2U サーバシャーシ HPC-7242、及び3U サーバシャーシ HPC-7320

内蔵ファン変更のお知らせ

この度、搭載している6cmファン(1750006419)終息のため、2U サーバシャーシ HPC-7242、及び3U サーバシャーシ HPC-7320内蔵ファンが変更となります。

Product Design Change in Product Appearance

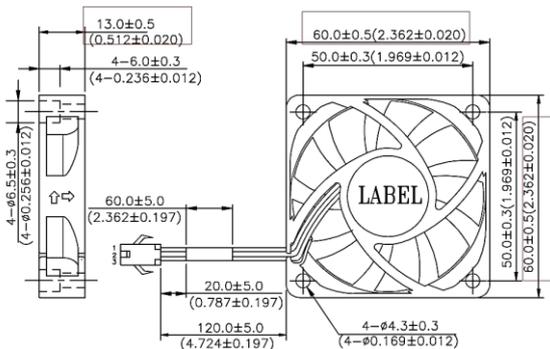
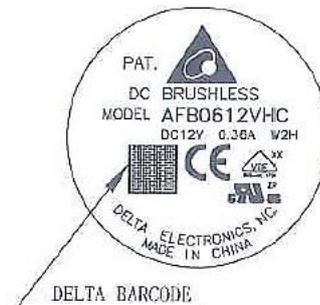
Affected Models	Current Component	New Component	Category	Outlook Difference	Reason
HPC-7320MB-00XE, HPC-7242MB-00XE, HPC7242MB1701-T, HPC7242MB1901-T, HPC7320MB1702-T	1750006419-01	1750009289-01	SYSTEM FAN	YES	1750006419-01 is EOL because the control IC of fan is EOL. The model name of FAN is the same. So, new FAN doesn't impact the system certification. New FAN has 4pin connector and additionally support PWM controlling.

P/N	Frame Size	Power Consumption	Speed	Air Flow	Air Pressure	Noise
Current FAN	1750006419-01	60x60x13	2.88W	3Pin	5400rpm	27.72 CFM	0.252 Inch-H ₂ O
New FAN	1750009289-01	60x60x13	2.4W	4Pin	5400rpm	27.72 CFM	0.252 Inch-H ₂ O

Current: 1750006419-01

- Model AFB0612VHC-BF1D

New: 1750009289-01

- Model AFB0612VHCW2H
